Luensmann Off-Site Water Main Extension (Phase I) Project

Job No.: 23-1043

ADDENDUM 2

Date: November 22, 2023

PLAT NO.:
 JOB NO.: 12473-09
 DATE: MARCH 2023
 DESIGNER: CD
 CHECKED: MP DRAWN: CD
 SHEET: C3.00

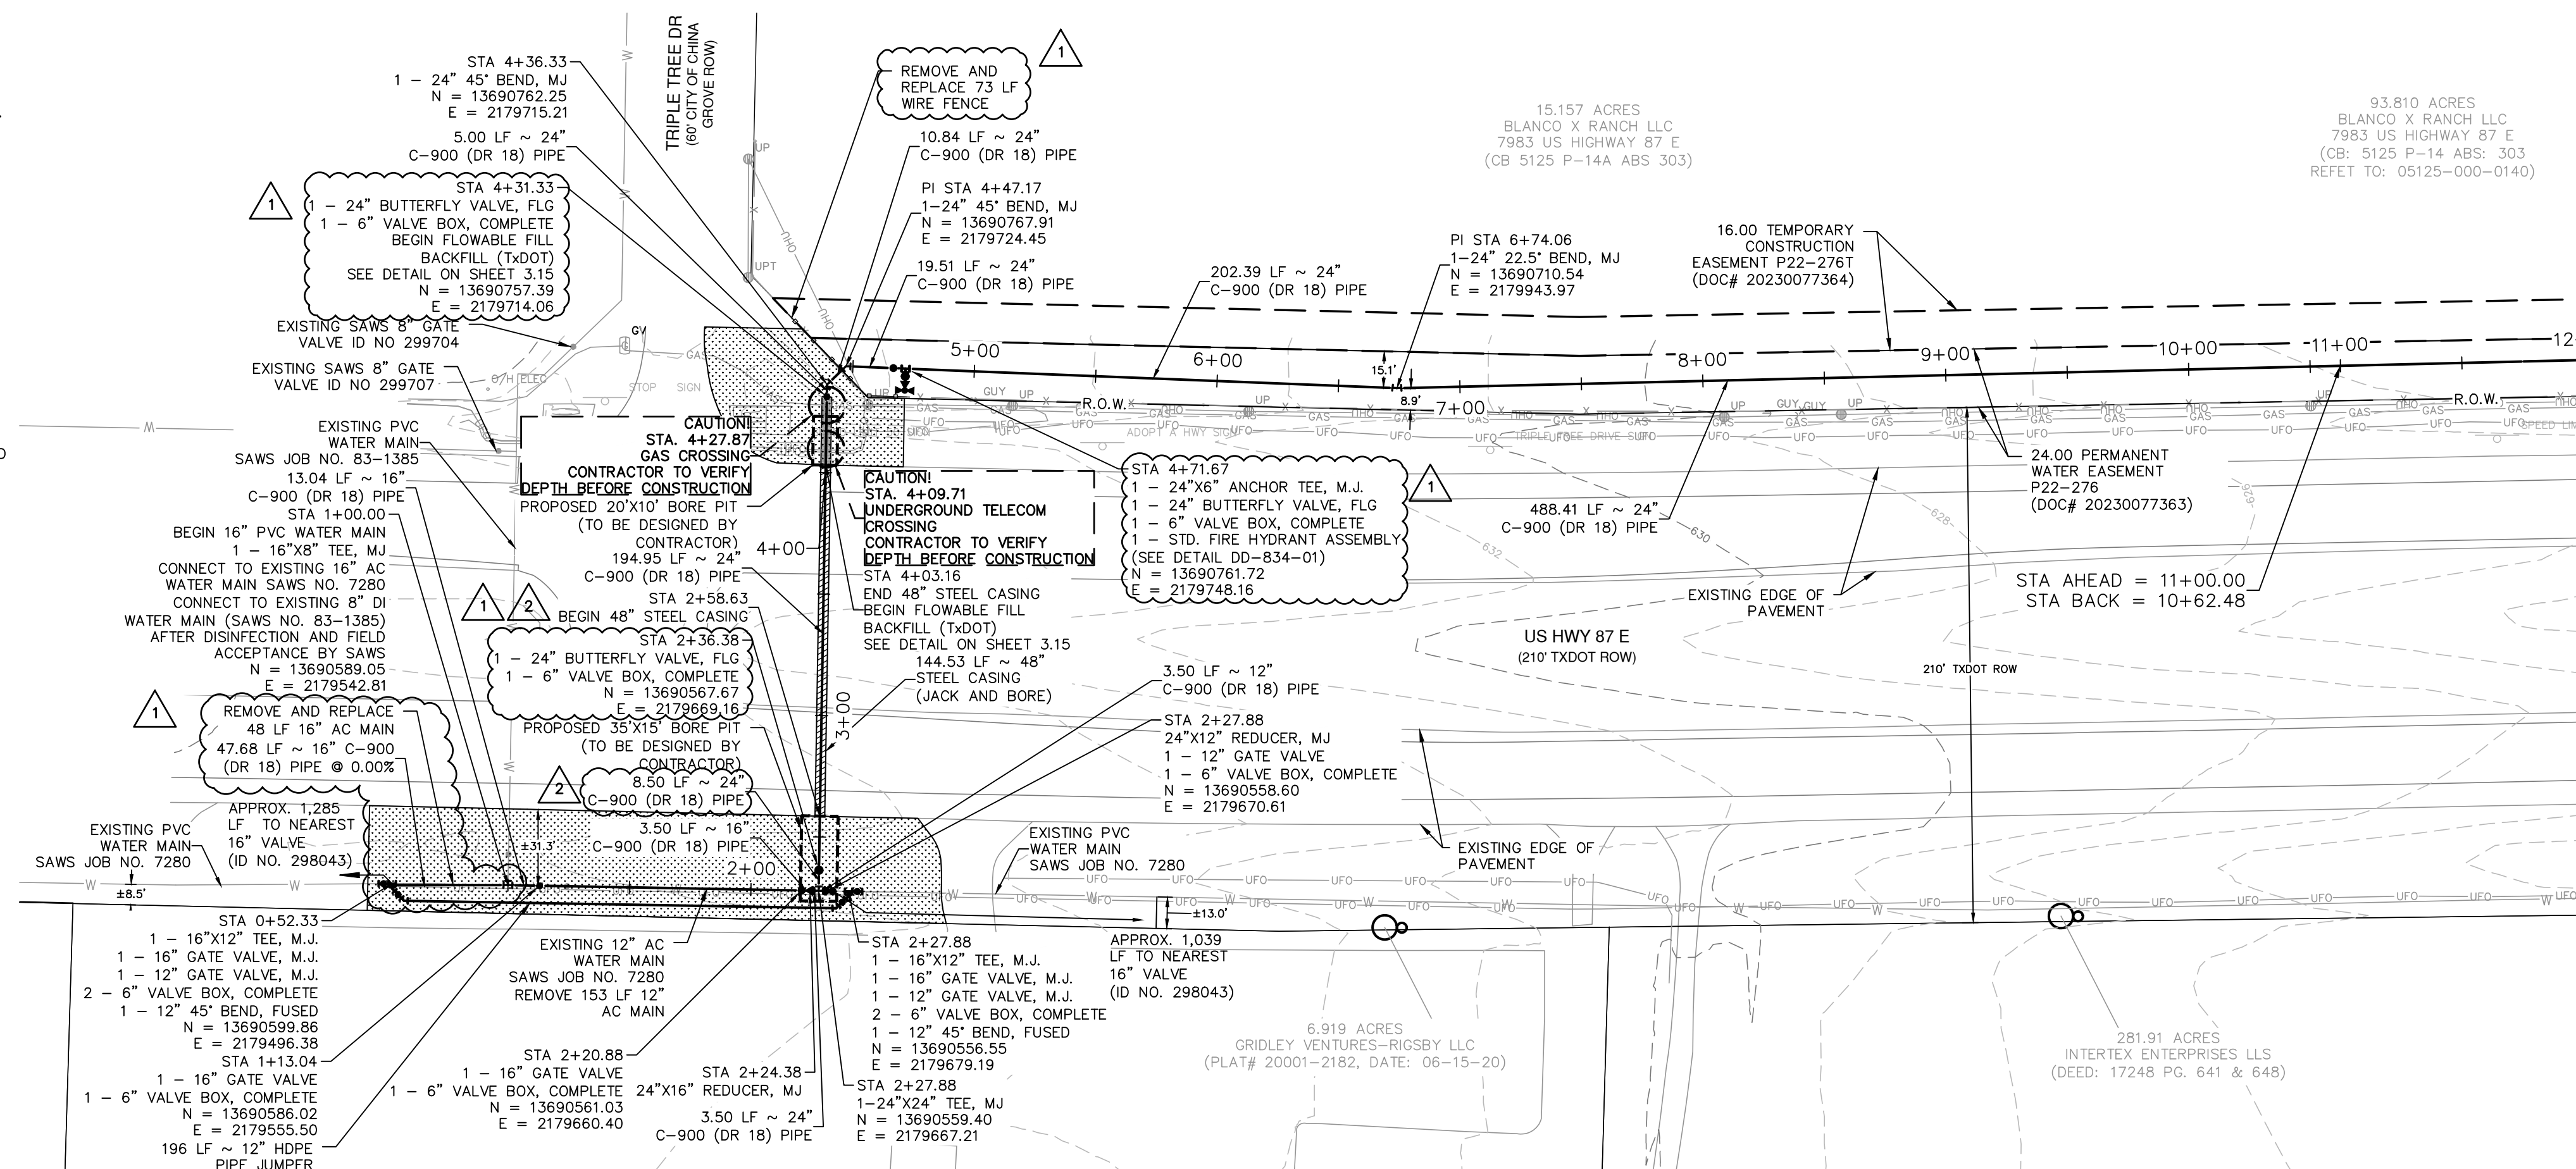
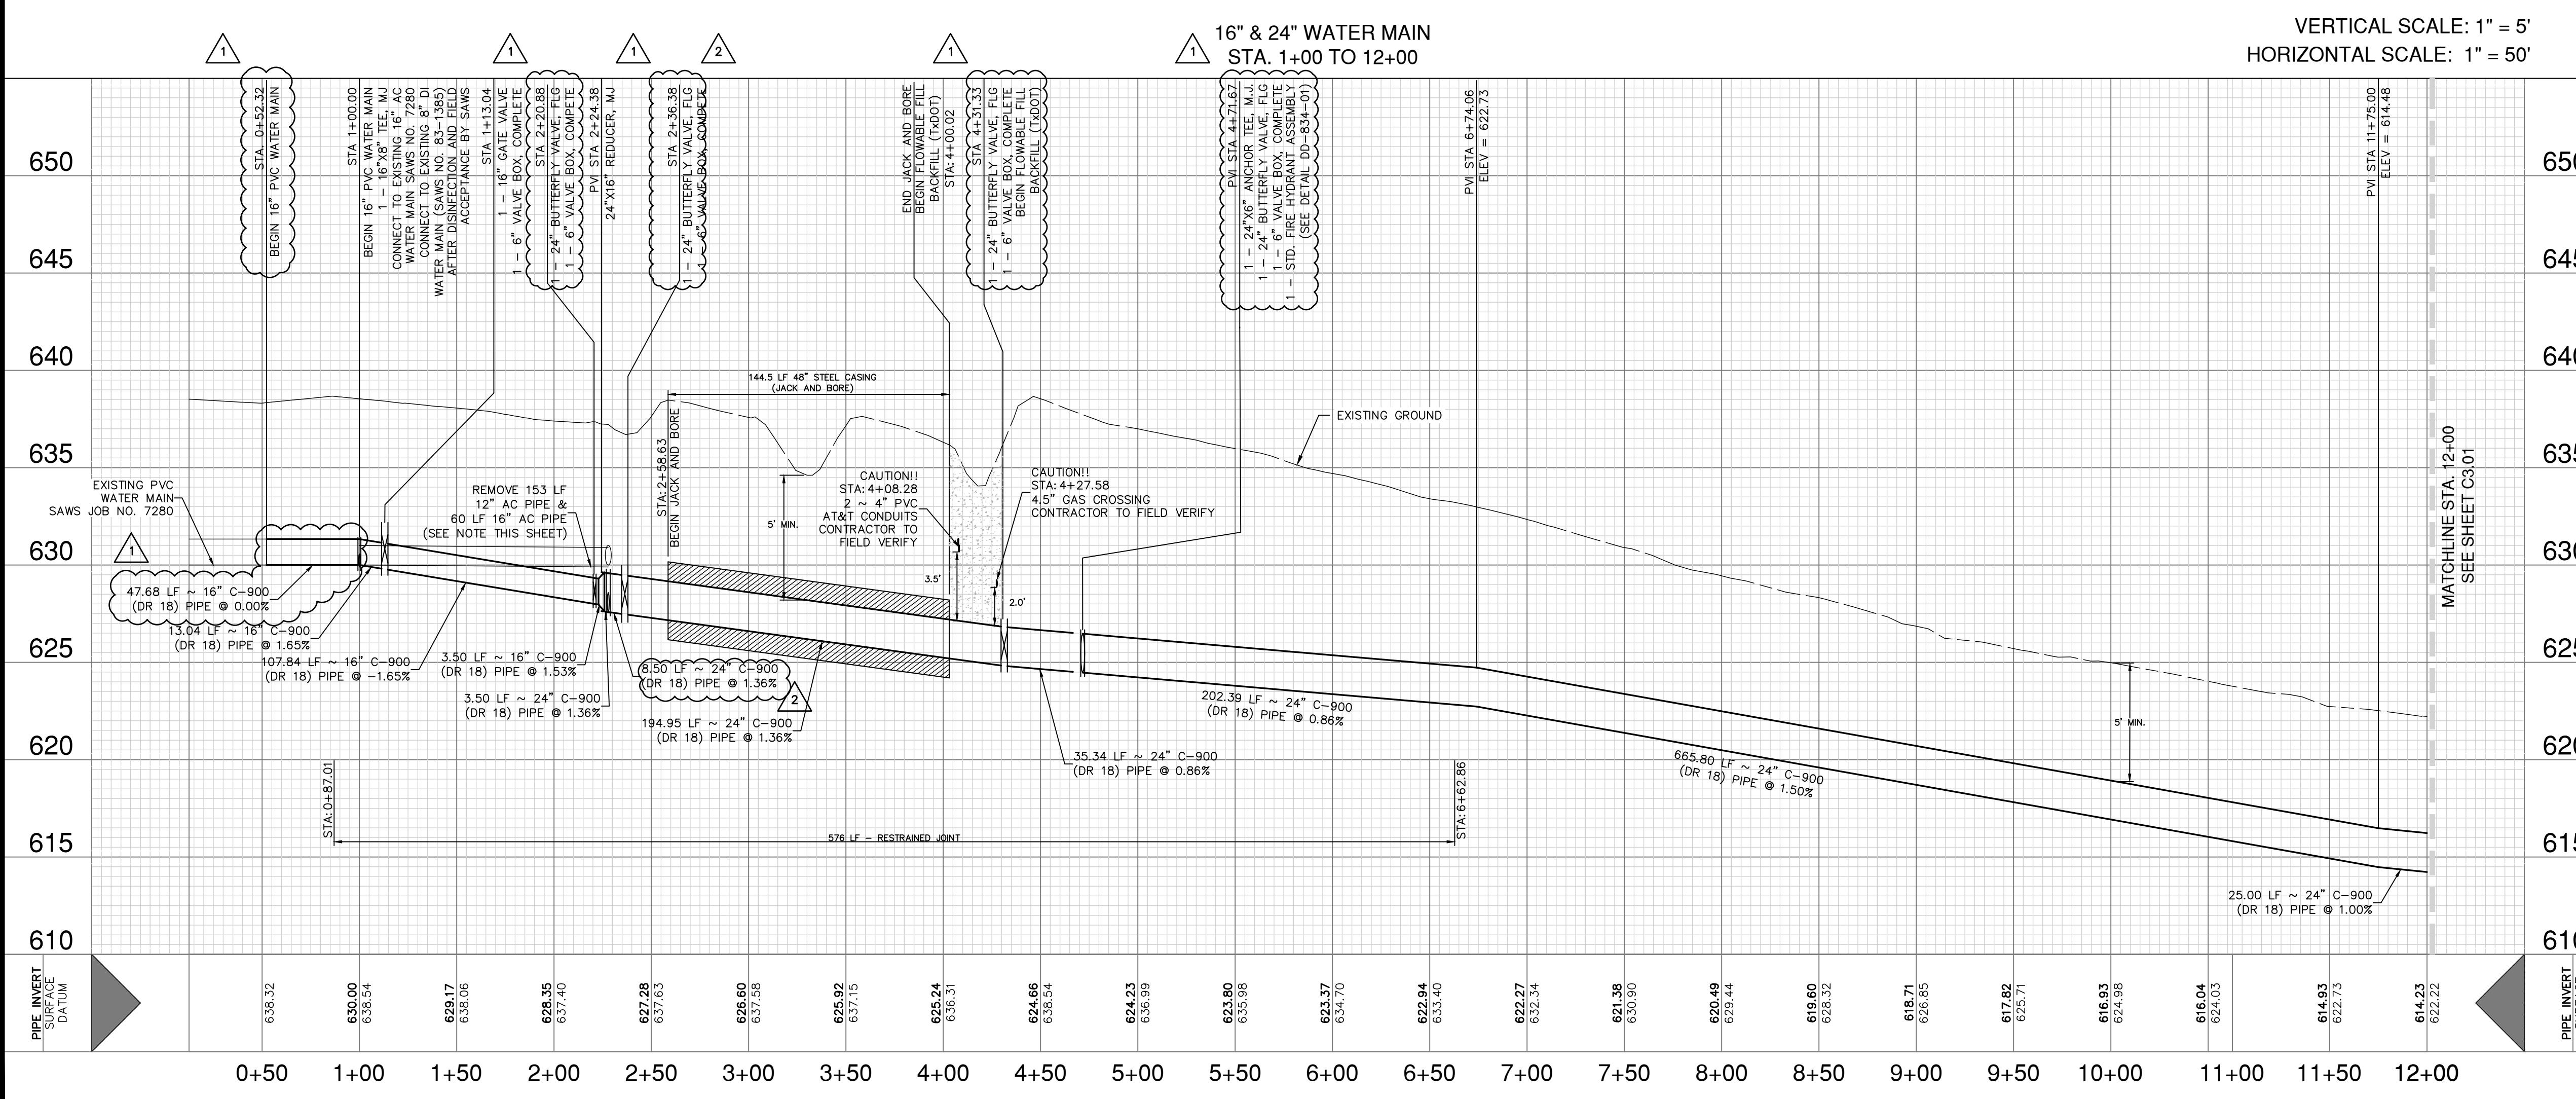
- 2. Question:** Flanged butterfly valves were called for in Addendum 1. How will these be connected per SAWS details? None of these methods are going to work with the amount of pipe going in between the valve and the MJ fittings. Typically all underground valves are MJ connection and above ground or valves in a vault are supposed to be flanged. Can you please clarify or provide a new detail on how you are wanting the connection to the butterfly valves?

1. **Remove** sheets C3.00 through C3.07 in their entirety and **replace** with the versions included in this addendum.

Response: See Changes to the Plans #1. The butterfly valve locations have been revised to allow for installation following SAWS specifications.
